### Proposed Revisions to a Standard Plans Index

Index Number: 521-620

Sheet Number (s): 2 of 4

Index Title: Concrete Barrier/Raised Sidewalk - Wall Coping

**TYPICAL SECTION THRU PRECAST COPING WITH C-I-P RAISED SIDEWALK AND RETAINING WALL AT EXPANSION JOINTS (32" Vertical Shape Shown, 42" Vertical Shape Similar)**

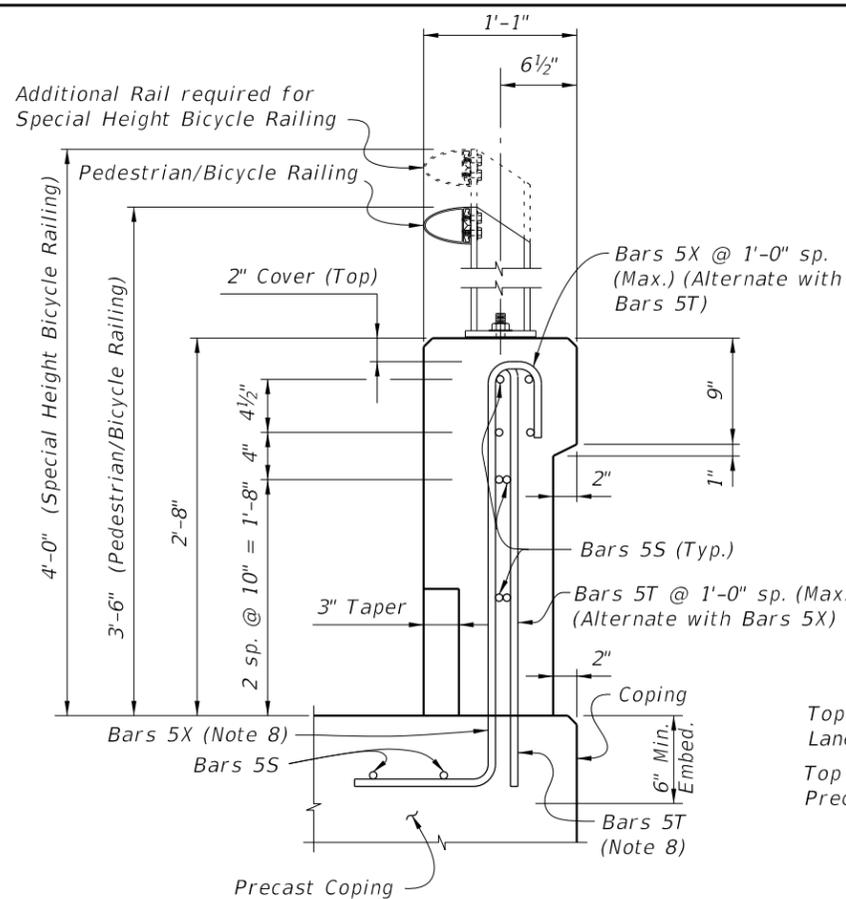
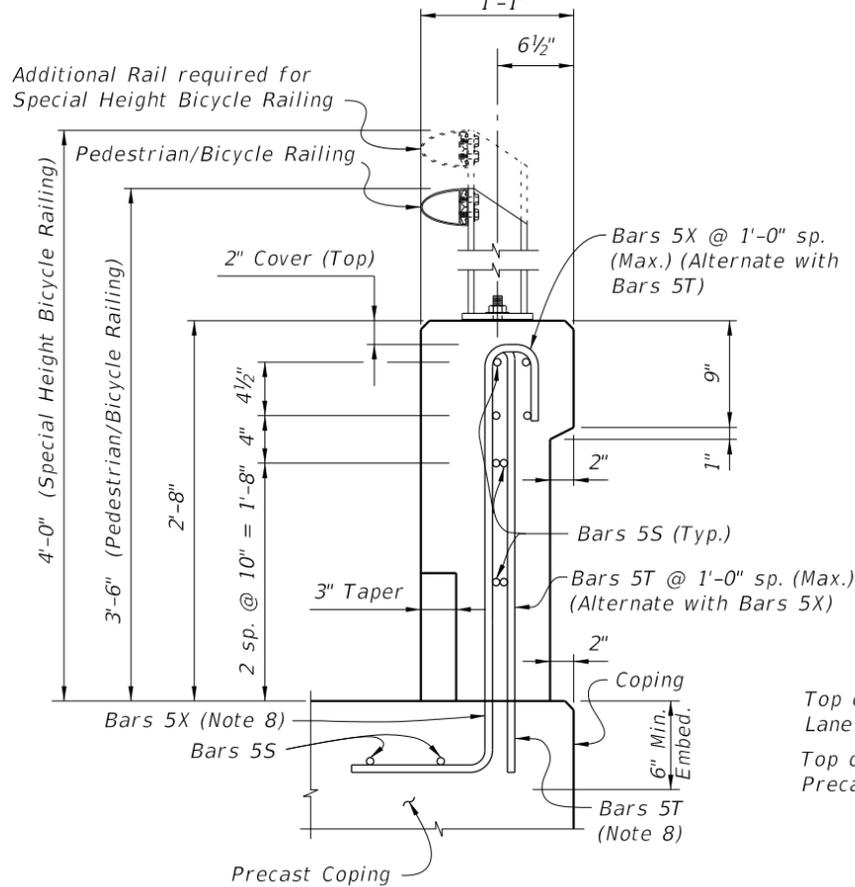
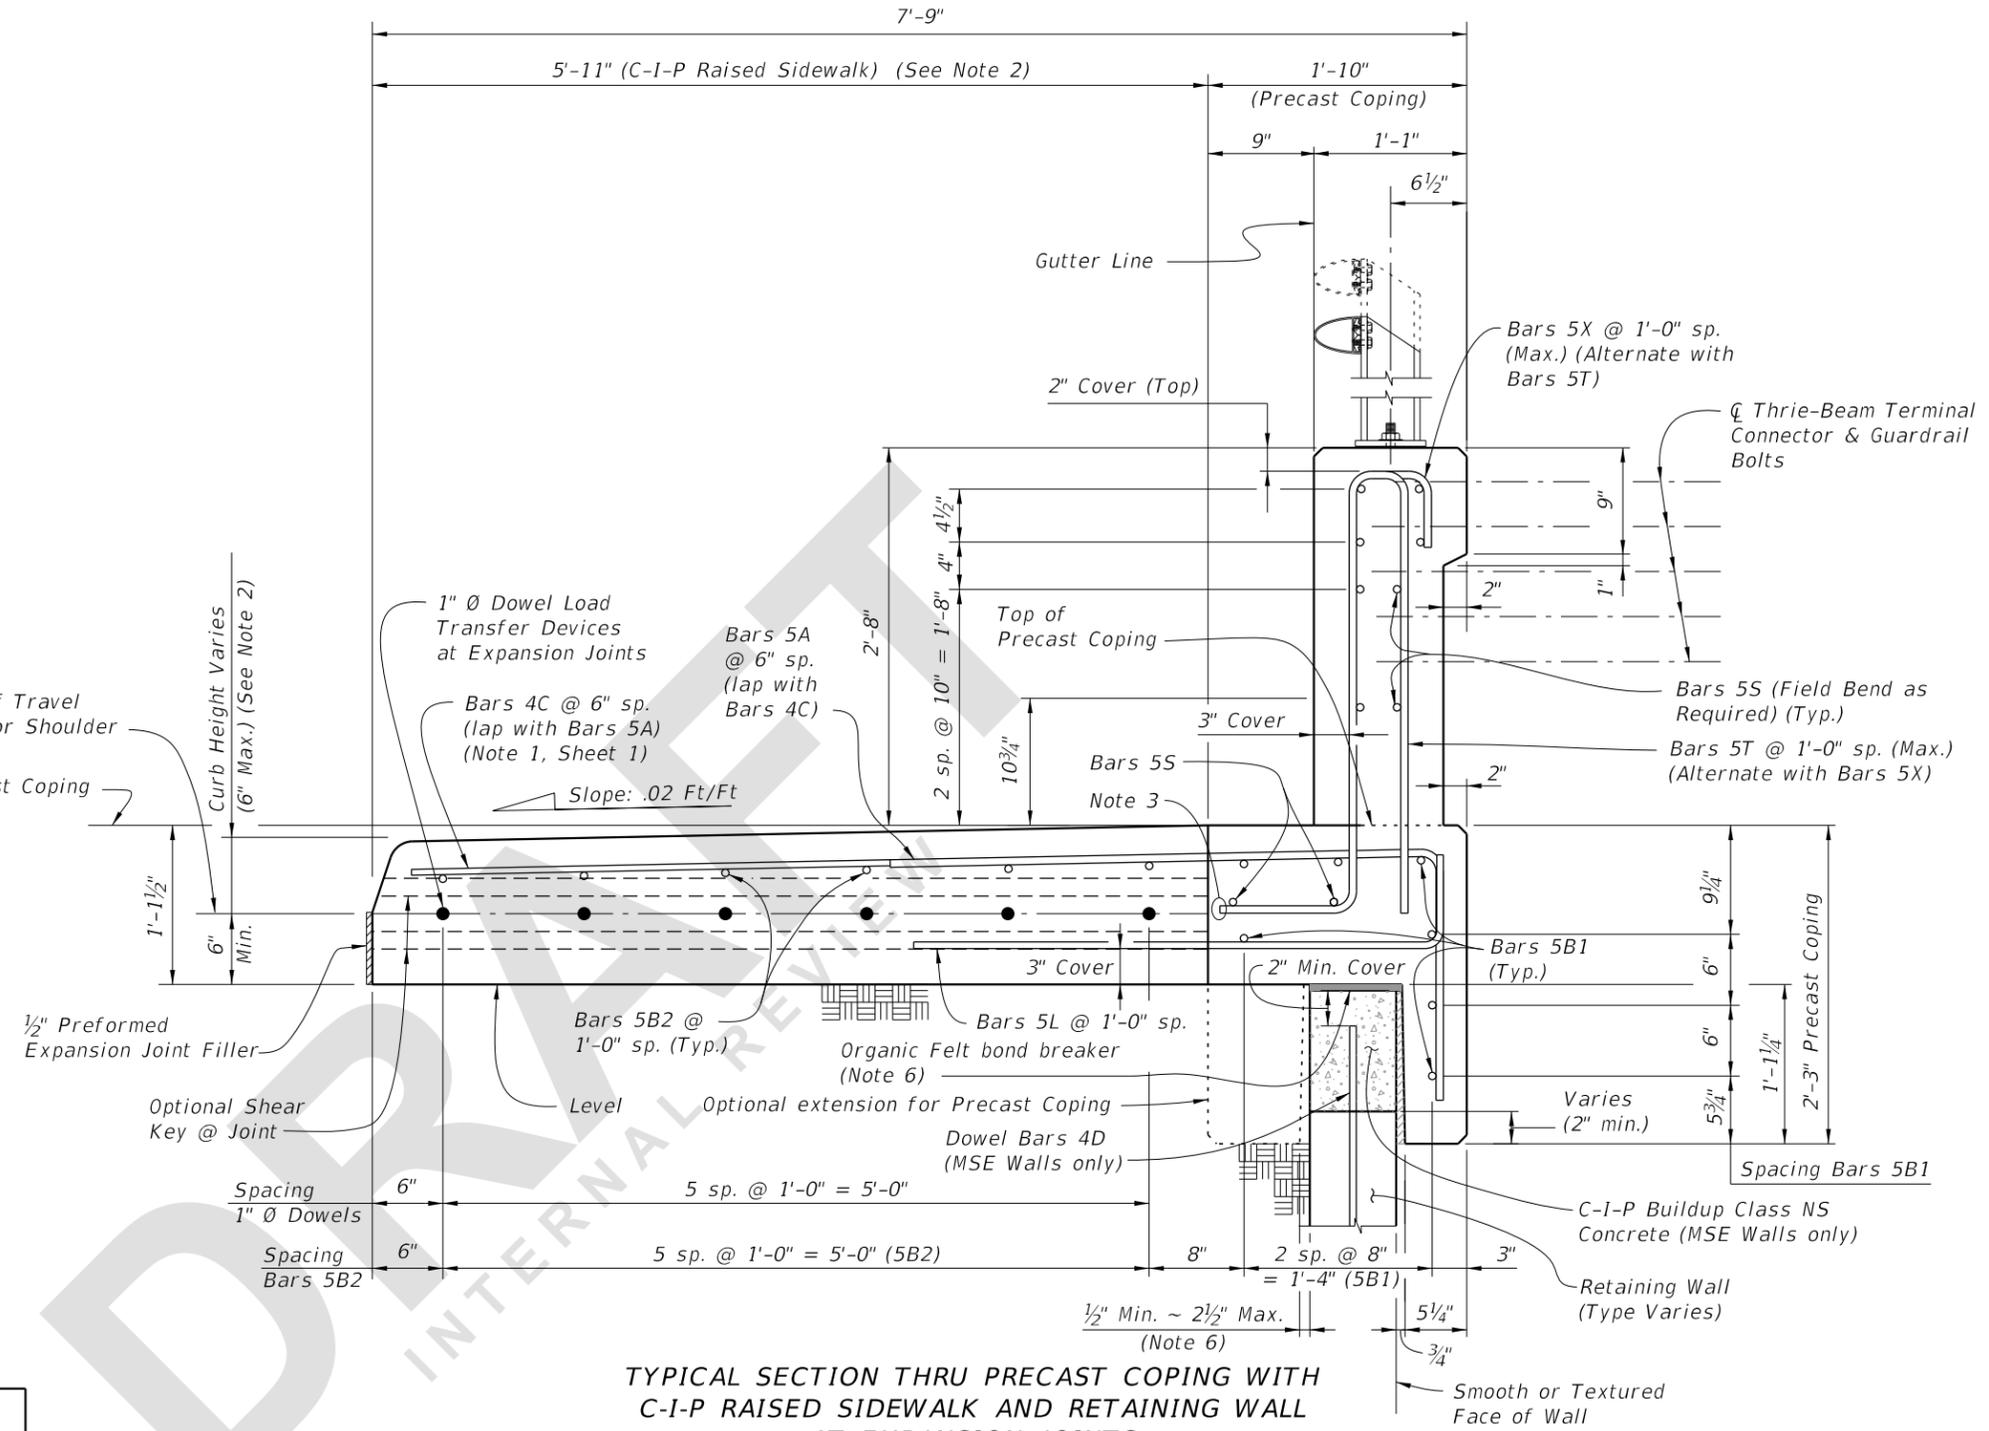
Changed C-I-P Buildup Concrete (1'-1" Max.) callout in the TYPICAL SECTION THRU PRECAST COPING WITH C-I-P RAISED SIDEWALK AND RETAINING WALL AT EXPANSION JOINTS to C-I-P Class NS Concrete (1'-1" Max.).

CIP buildup concrete type was never clarified. SDO review deems Class NS is acceptable because the concrete buildup section is not meant to transfer any meaningful load to the wall other than self weight.

**CHANGED TO: Class NS Concrete**  $\frac{1}{2}$ " Min. ~  $2\frac{1}{2}$ " Max. (Note 6)
